CITY OF PUYALLUP SHORT PLAT NO. PLSHP20220003

A PORTION OF SW1/4 OF SW1/4, SECTION 28
 TOWNSHIP 20 NORTH, RANGE 4 EAST, W.M.

DWN. BY	KMA	DATE	8/19/2022	JOB NO.	22001
CHKD. BY	MKA	SCALE	N/A	SHEET	1 OF 2

DWN. BY	KMA	DATE	8/19/2022	JOB NO.	22001
CHKD. BY	MKA	SCALE	1" = 50'	SHEET	2 OF 2

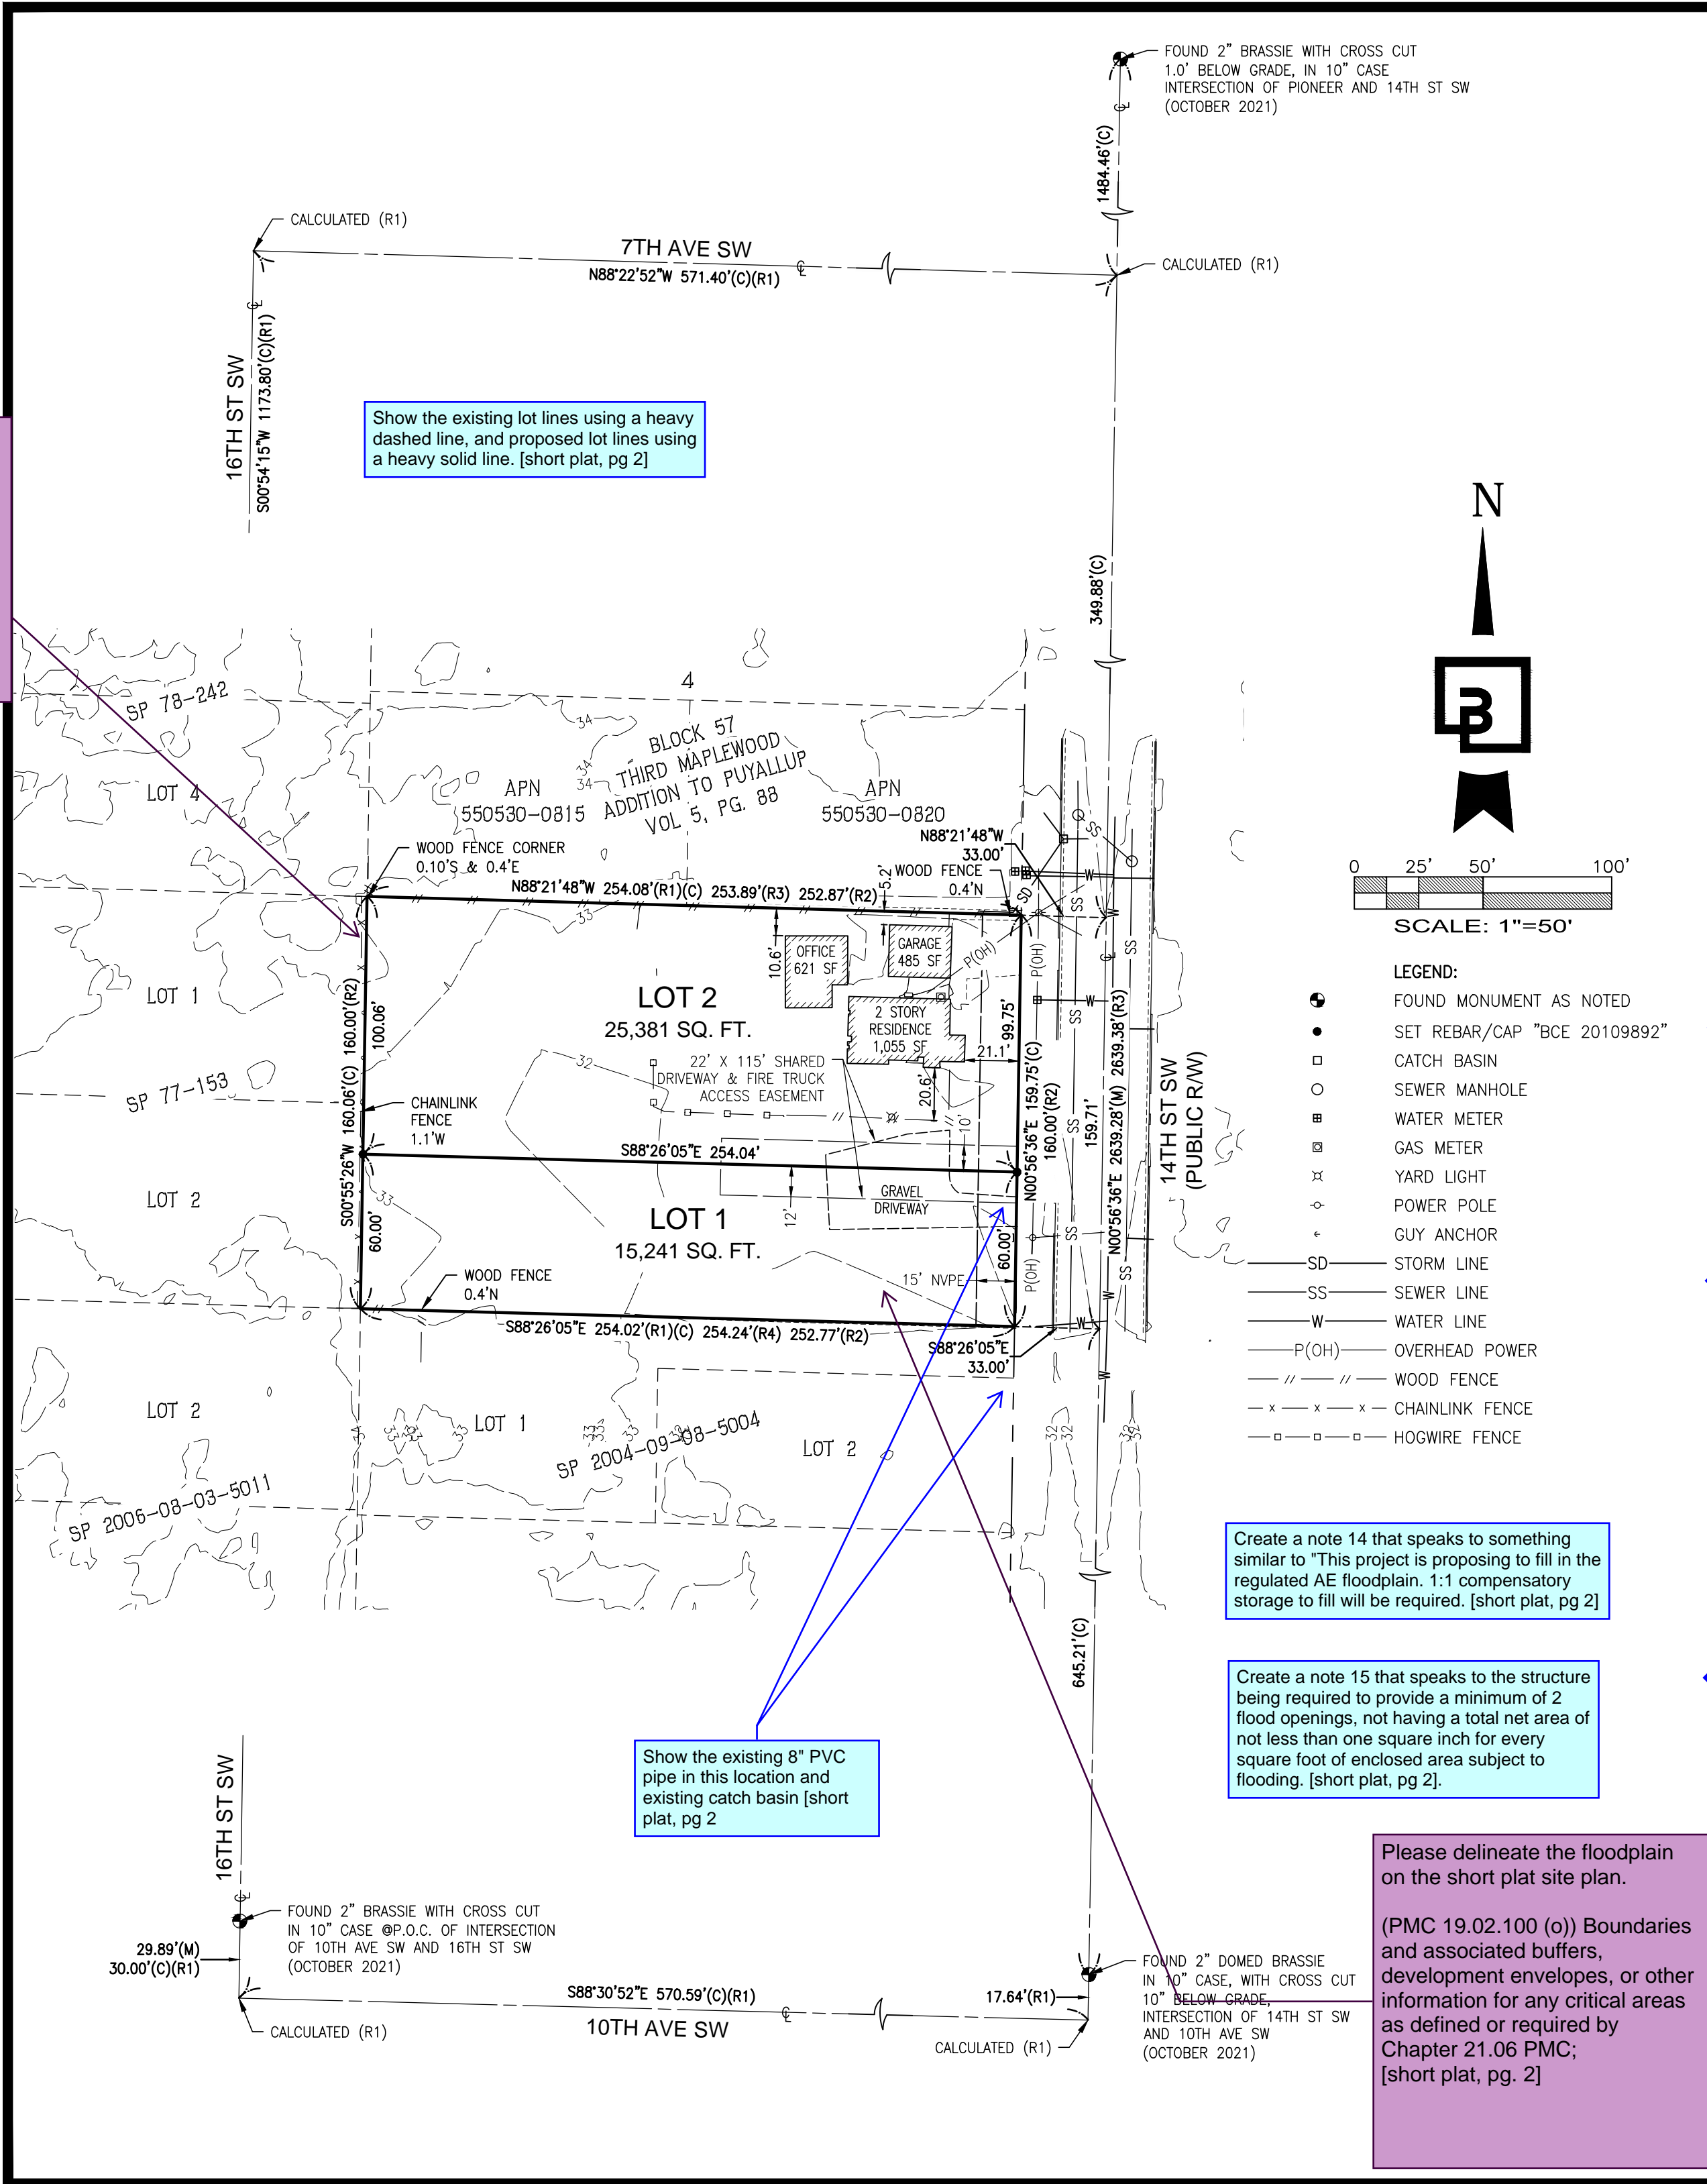
Delineate the existing lot lines using a heavy dashed line, and the proposed lot lines shown using a heavy solid line (PMC 19.02.100 (g)). In the most recent submittal, all the lines are heavy solid lines [short plat, pg. 2]

Show the existing lot lines using a heavy dashed line, and proposed lot lines using a heavy solid line. [short plat, pg 2]

Create a note 14 that speaks to something similar to "This project is proposing to fill in the regulated AE floodplain. 1:1 compensatory storage to fill will be required. [short plat, pg 2]

Create a note 15 that speaks to the structure being required to provide a minimum of 2 flood openings, not having a total net area of not less than one square inch for every square foot of enclosed area subject to flooding. [short plat, pg 2].

Please delineate the floodplain on the short plat site plan. (PMC 19.02.100 (o)) Boundaries and associated buffers, development envelopes, or other information for any critical areas as defined or required by Chapter 21.06 PMC; [short plat, pg. 2]

Show the existing 8" PVC pipe in this location and existing catch basin [short plat, pg 2]
